Amendment Report

WELLINGTON NORTH SOLAR PLANT

AUGUST 2019

Wellington North Solar Plant

Figure 2-1 Updated proposal layout.

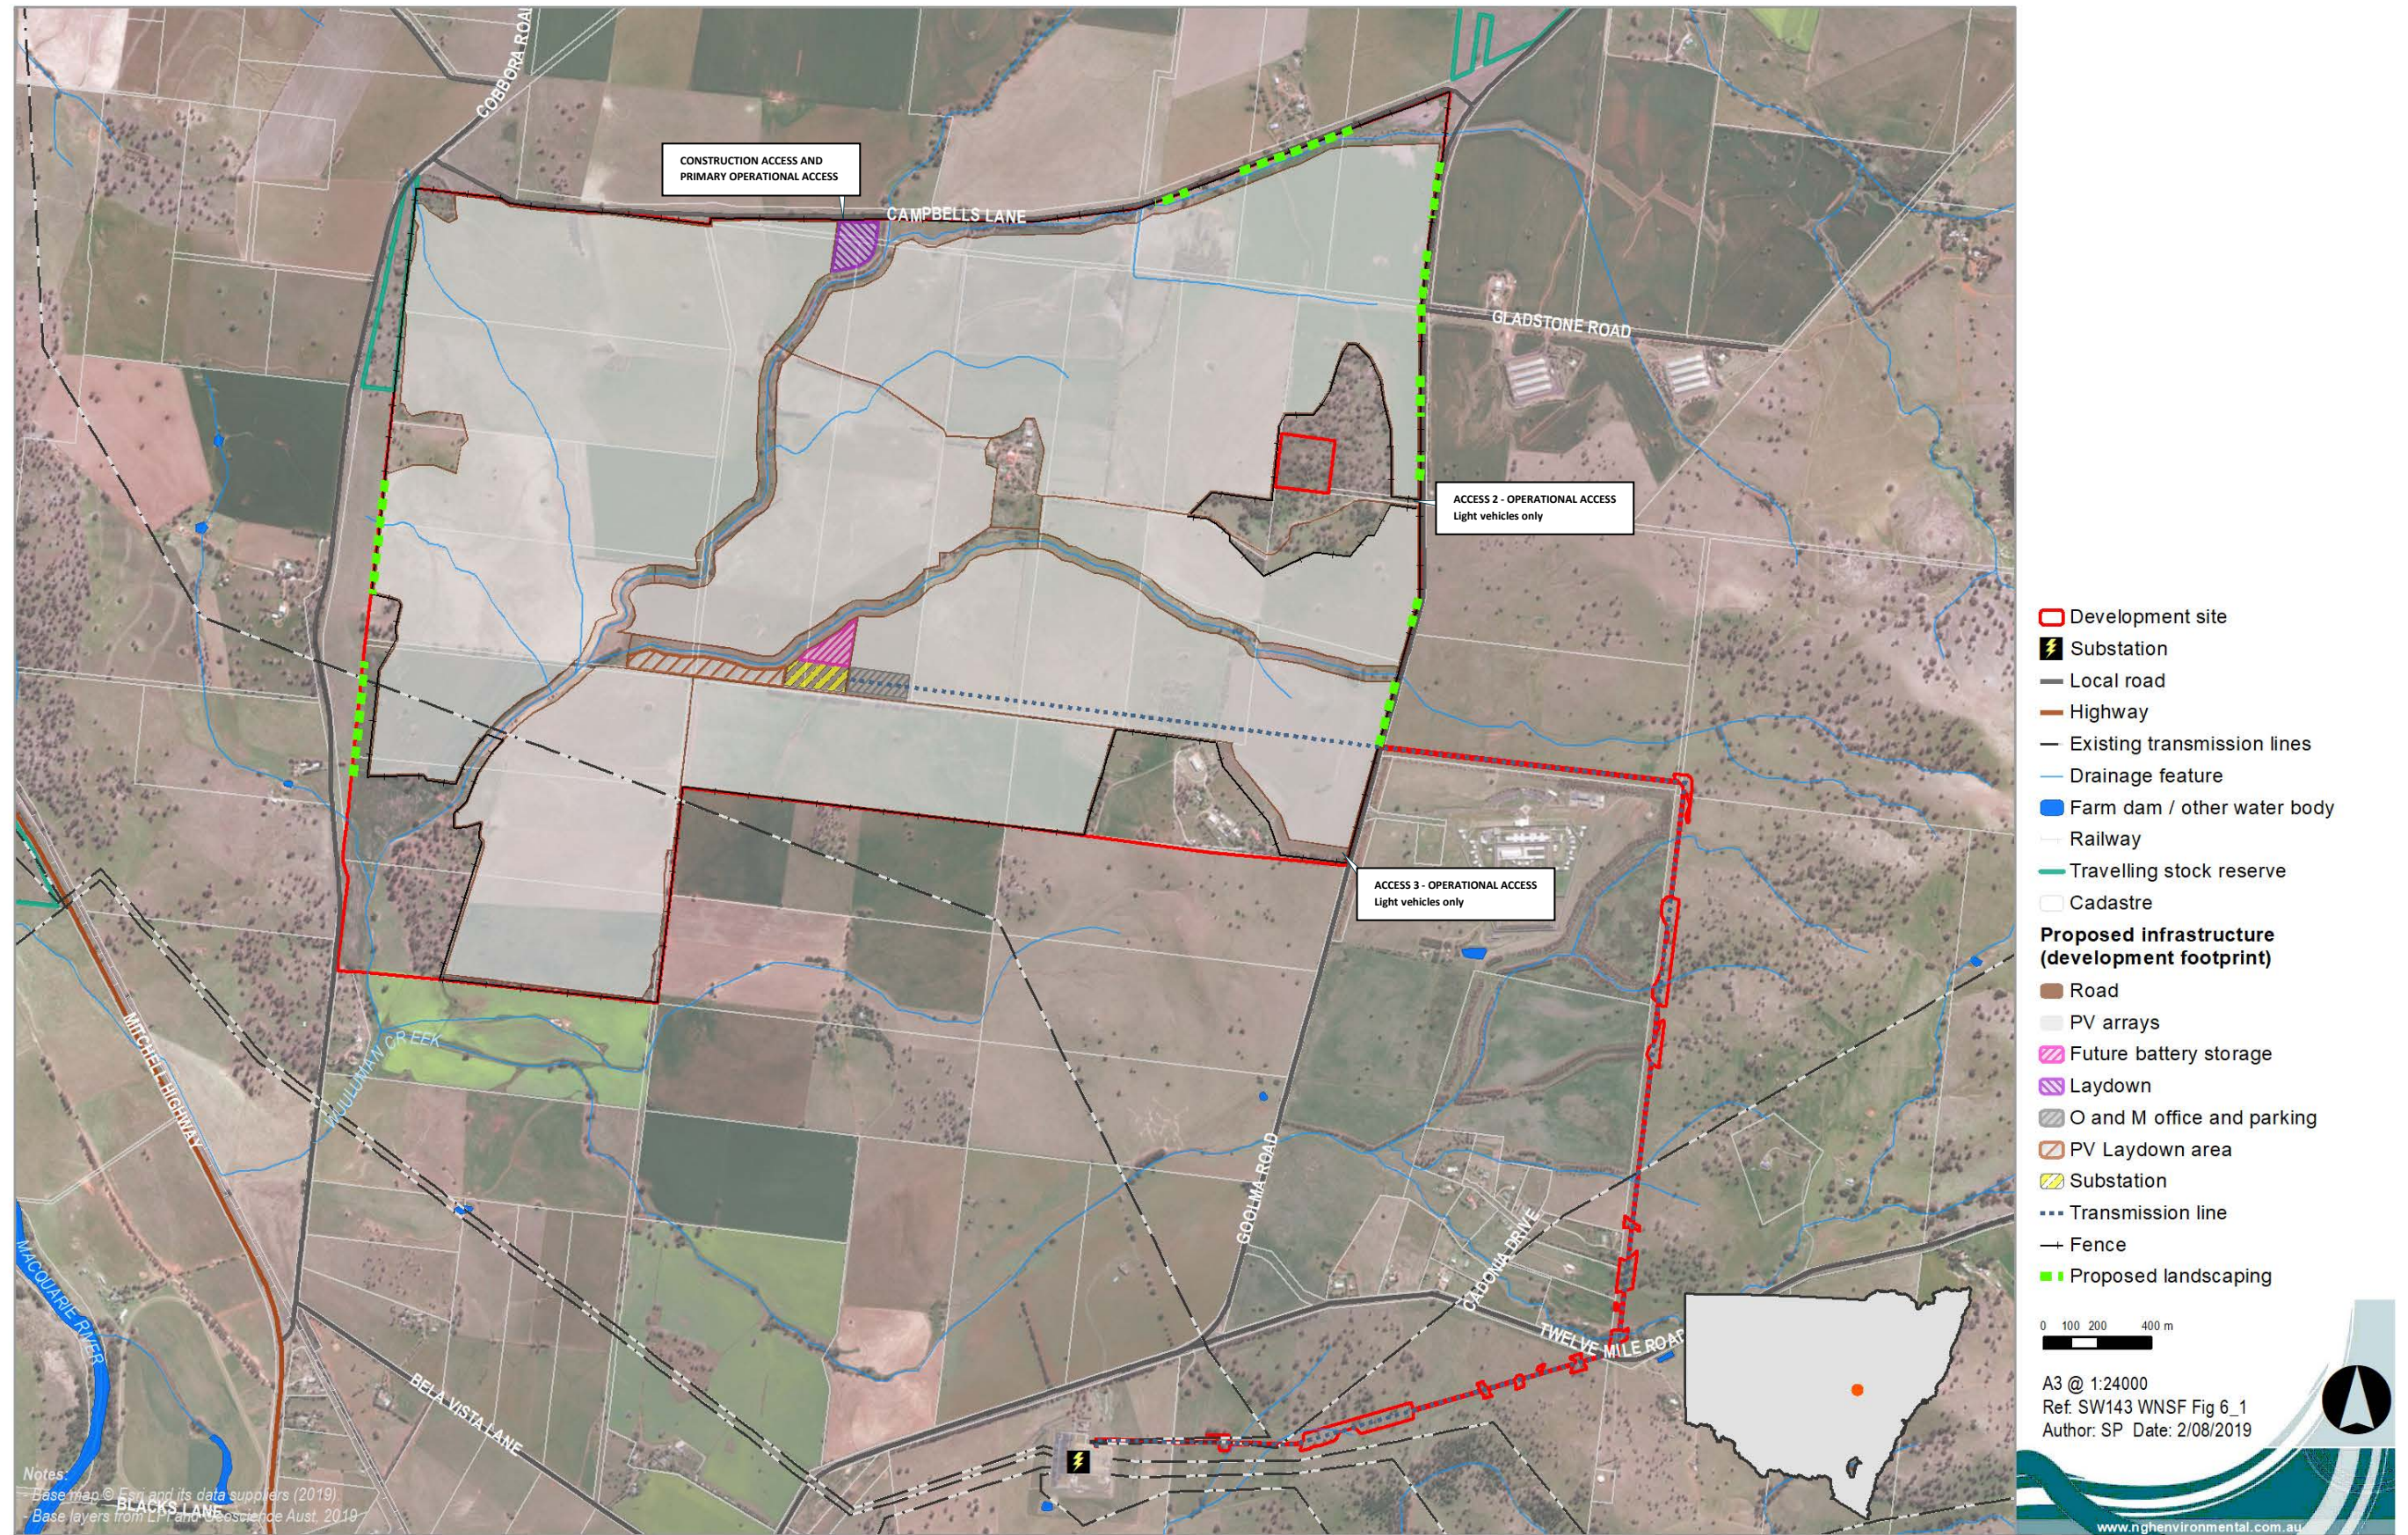
The proposed new eastern transmission line option that would connect the solar plant to the existing Wellington Substation would be a 132kV or 330kV overhead transmission line. From the solar plant site, the transmission line would cross Goolma Road, approximately 400m north of the Soil Conservation Service site access. It would continue east for approximately 1.1km to the eastern side of the Wellington Correctional Centre, before heading south to Twelve Mile Road for approximately 2km. It would cross Twelve Mile Road and enter the Wellington Substation from the east (refer to Figure 2-1). The transmission line would occur in the following lots and Deposited Plans (DPs):

easement. This was undertaken to identify the most appropriate route within the study area. The area of vegetation removed within the easement would be approximately 9.43ha (as determined in the revised BDAR-v2.3, NGH 2019b). The line would involve three different land owners. Table 2-1 compares the proposed new eastern transmission line option to the two transmission line options presented within the EIS. The new eastern transmission line is considered to be substantially the same as the transmission line options presented within the EIS as the impacts are kept to a minimum.

- **Access Point 1:** The primary access point would be via Campbells Lane along the northern boundary of the site. This access would be used for light and heavy vehicles.
- **Access Point 2:** The existing driveway off Goolma Road that leads to the Soil Conservation Service facilities. The access point may continue to be utilised by Soil Conservation Service staff in addition to light vehicle access to the solar plant. By exception only, the access point may be required for some heavy vehicle movements, such as the delivery high voltage transformers.
- **Access Point 3:** The existing driveway off Goolma Road that leads to the residential dwelling on the property. This access point would be utilised by light vehicles only.

Under the proposed amendment, no construction access for the solar plant would be via Goolma Road. The vehicles that would access the solar plant site via Goolma Road during operation would be limited to light vehicles for operational staff only. The impacts of light vehicle use remain the same and the impacts have been sufficiently assessed in the *Traffic Impact Assessment* (GHD, 2018) (Appendix K of the EIS).

Figure 2-2 Updated constraints map

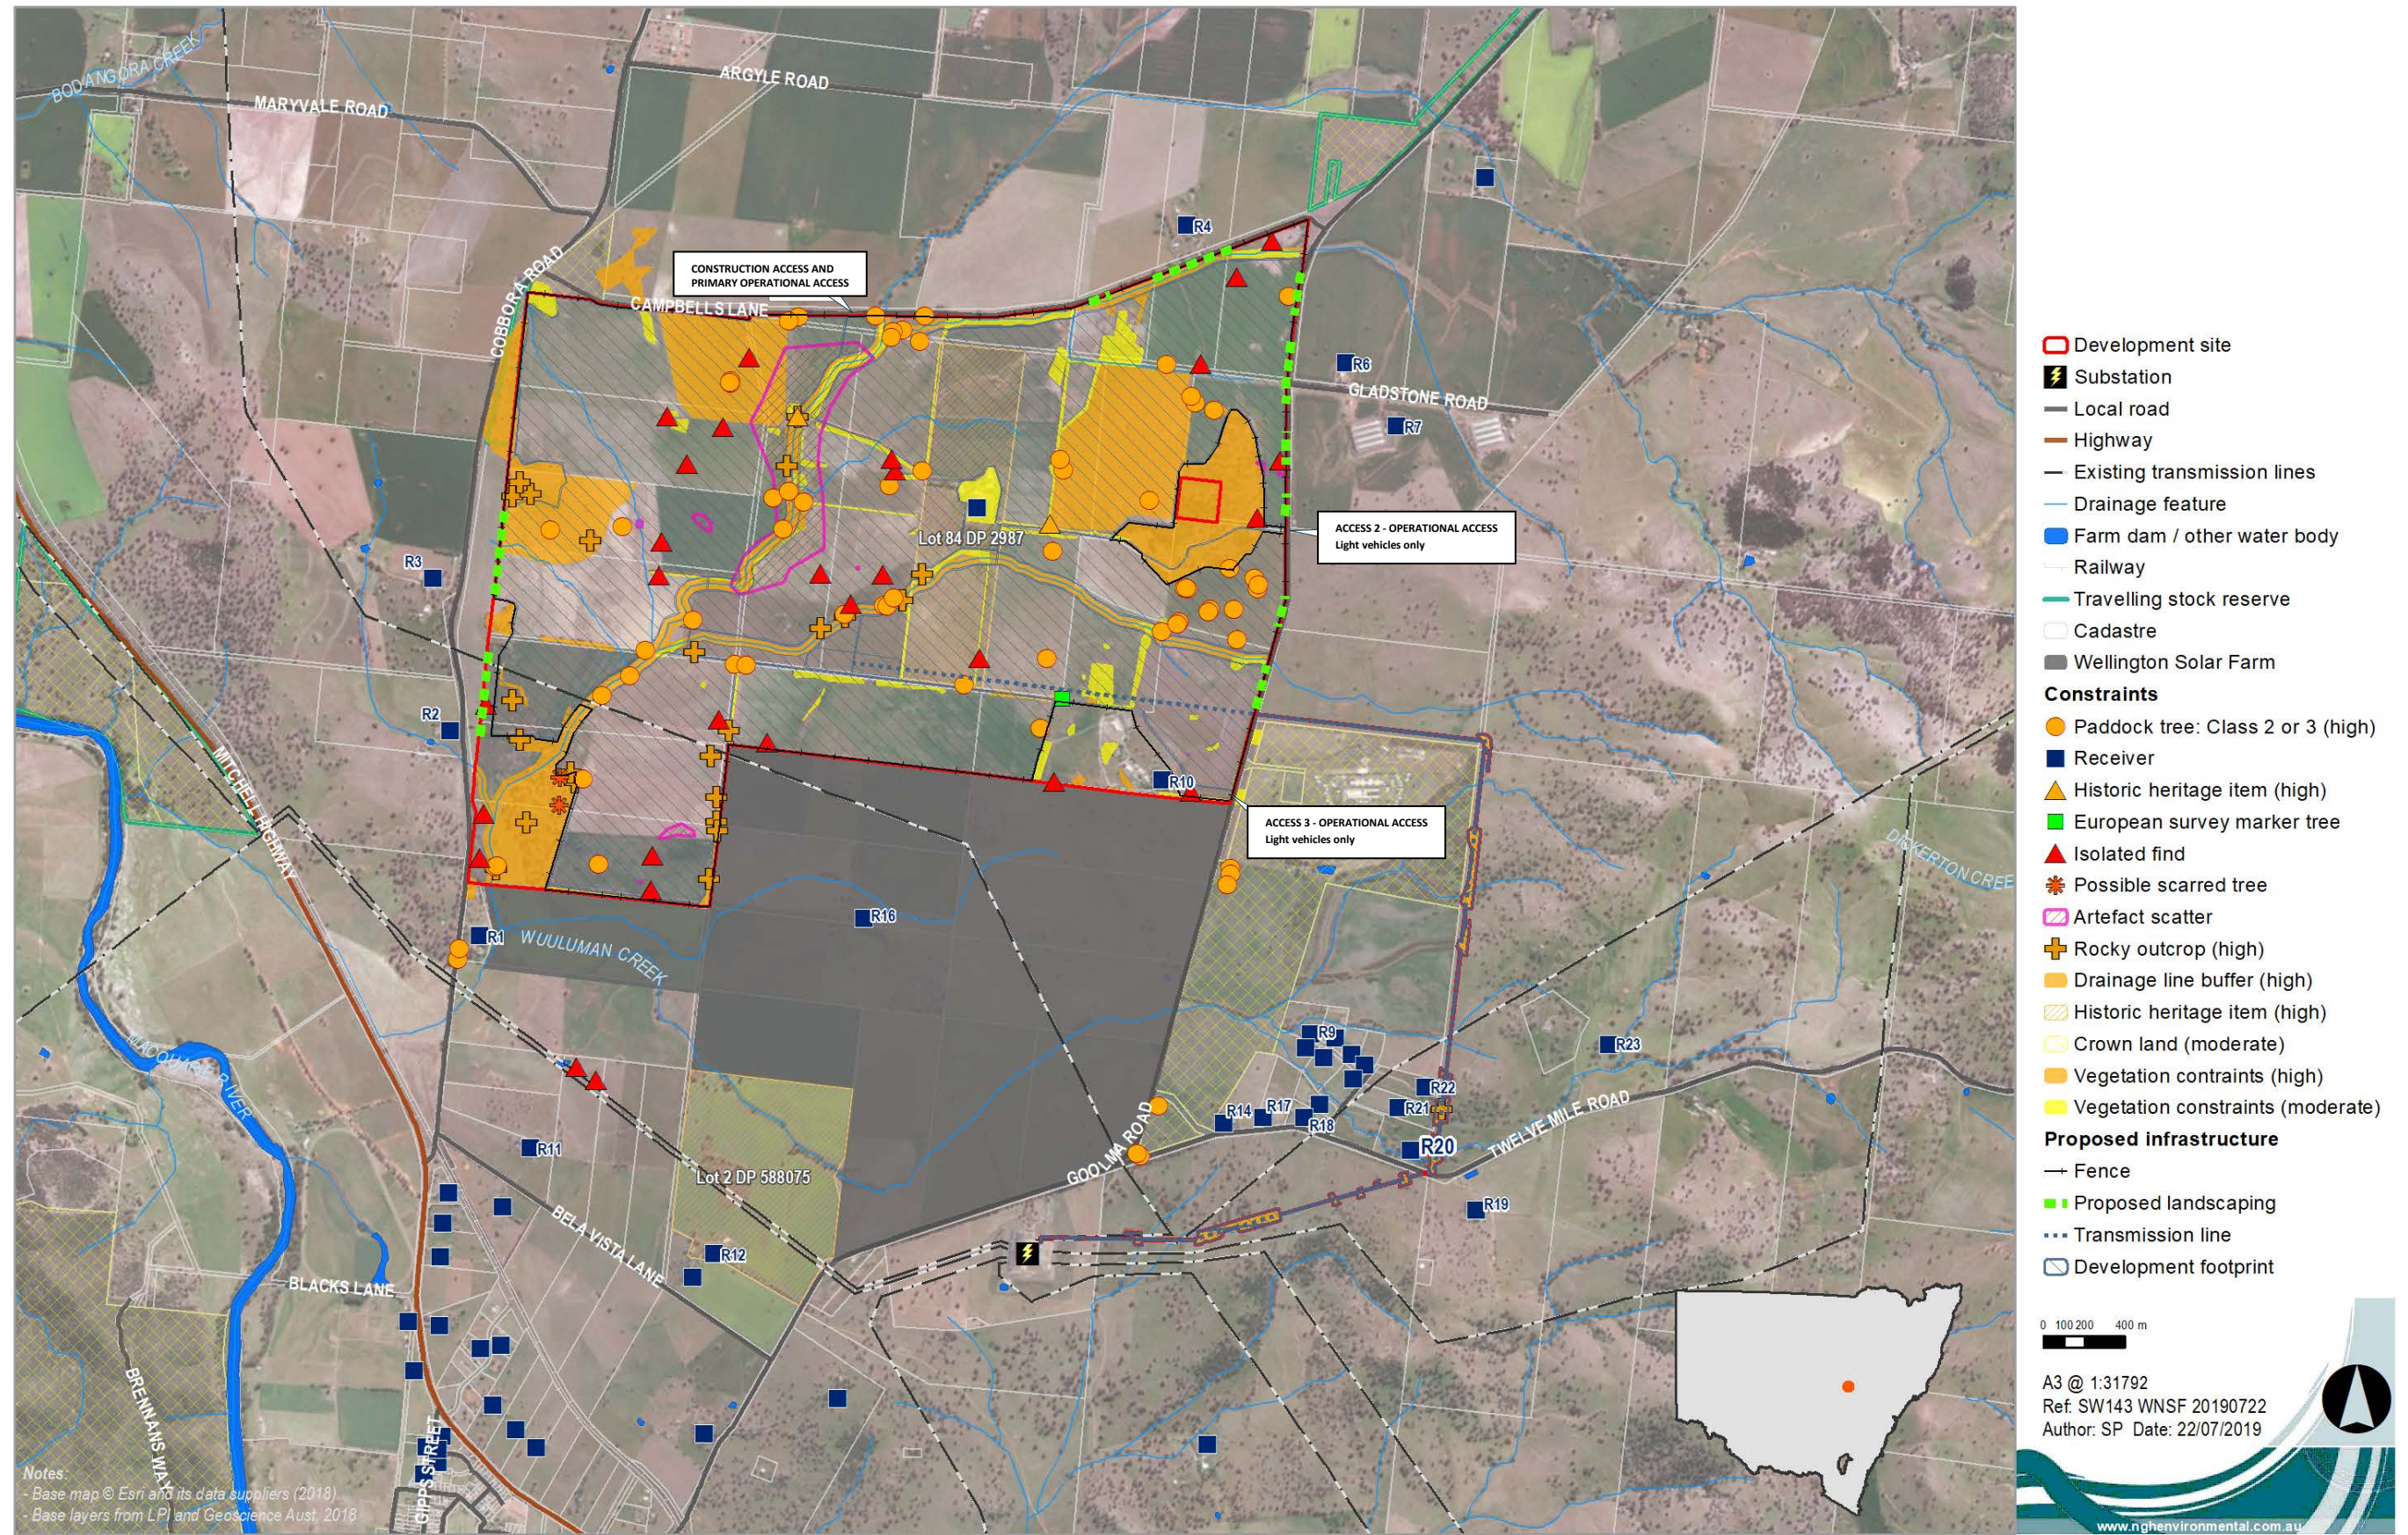
EIS Eastern transmission line option (underground)	EIS Western transmission line option (overhead)	New Eastern Transmission line, now proposed
Maximum easement footprint (hectares)	7	31	30-31
Number of non-involved landowners directly adjacent to the easement	2	5	8 (inclusive of 3 landowners that would be separated from the easement by Twelve Mile Road, refer to Figure 2-2)
